CITY OF NEWBURYPORT
OFFICE OF PLANNING AND DEVELOPMENT
60 PLEASANT STREET • P.O. BOX 550
NEWBURYPORT, MA 01950
(978) 465-4400 • (978) 465-4452 (FAX)

RE: Special Permit & Site Plan Approval – Filing
Newburyport Intermodal Transit & Parking Facility (Parking Garage)

DRAWING TITLE:
BUILDING ELEVATIONS

1 NORTH ELEVATION
A-201 SCALE: 3/32" = 1'-0"

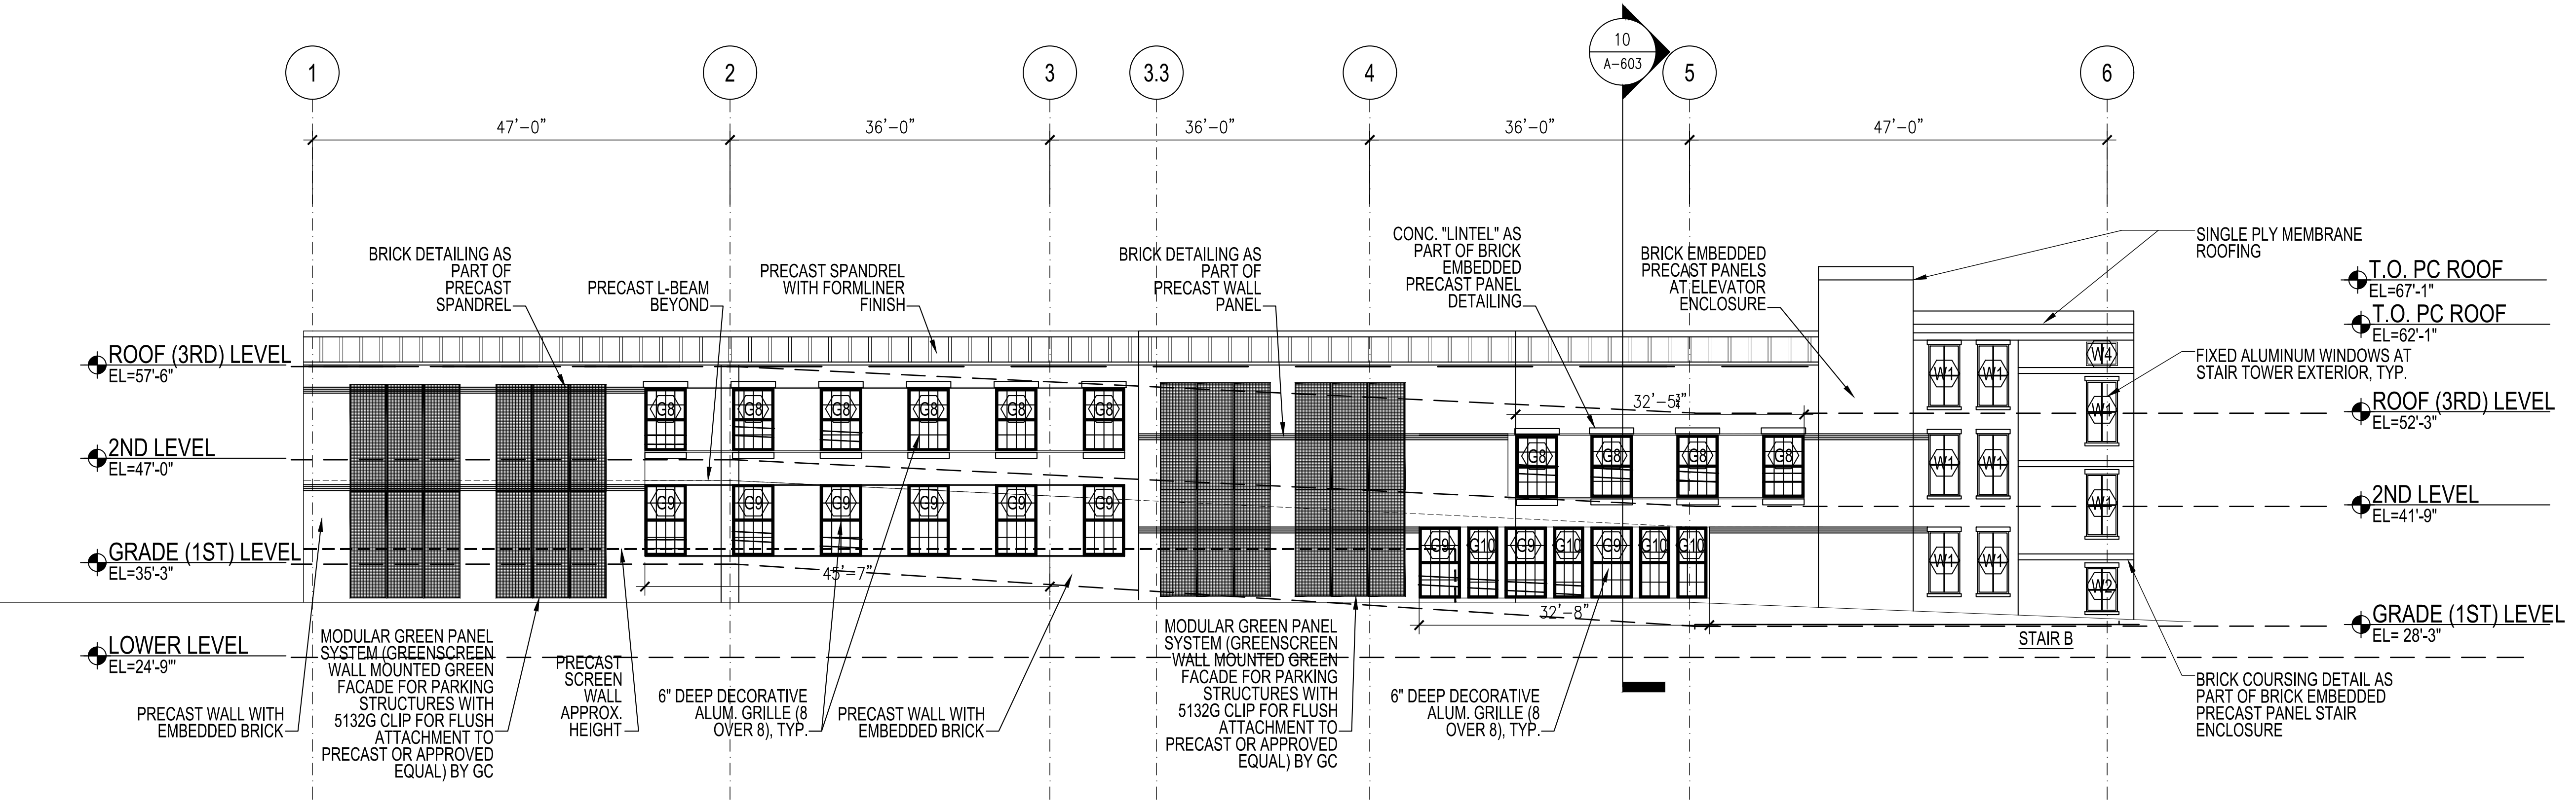
- Q23.** Drawing A201/1 elevation shows "City of Newburyport, logo, and MVRTA lettering. Who is responsible for providing this signage? If the GC is responsible, please provide more details.

- A.** The General Contractor shall provide and install signage. All signage to be aluminum. "City of Newburyport" font shall be MS Reference Sans Serif, 8"h x 2" thick, 1" spacing between letters and 3" spacing between rows of text. Emblem logo to be 3' in diameter, spaced 6" from bottom of "City of Newburyport" lettering, and 1'-6" from top of "MVRTA" signage. "MVRTA" signage shall be 1'-6" h by 3' wide. High resolution logos will be provided to the General Contractor upon award.

- Q31.** There are exterior signs shown on elevations 1/A201 and 1/A202. These signs are not shown on signage plans or details. Are these signs to be included in GC bid? If so, can you provide details?

- A. Room numbers have been revised to align with the finish schedule, see sheets A-111 & A-403.
- Q33.** Elevation 1/A201 and Details 5,6/A502 show granite cladding. Where is the type of granite specified?

- A. Please see responses to Q23 and Q25 in this addendum.
- Q32.** Room numbers in the Finish Schedule don’t appear to match room numbers on the floor plan. Please correct.

- A. Veneer Granite shall be 1 3/16” thick, “Sierra White” with fine to medium grain as quarried by Cold Spring company with, pointed rough sawn finish or approved equal. A sample spectrum with the described classification shall be provided and no less than three samples of selected class with varying degree of finish shall be provided for selection.
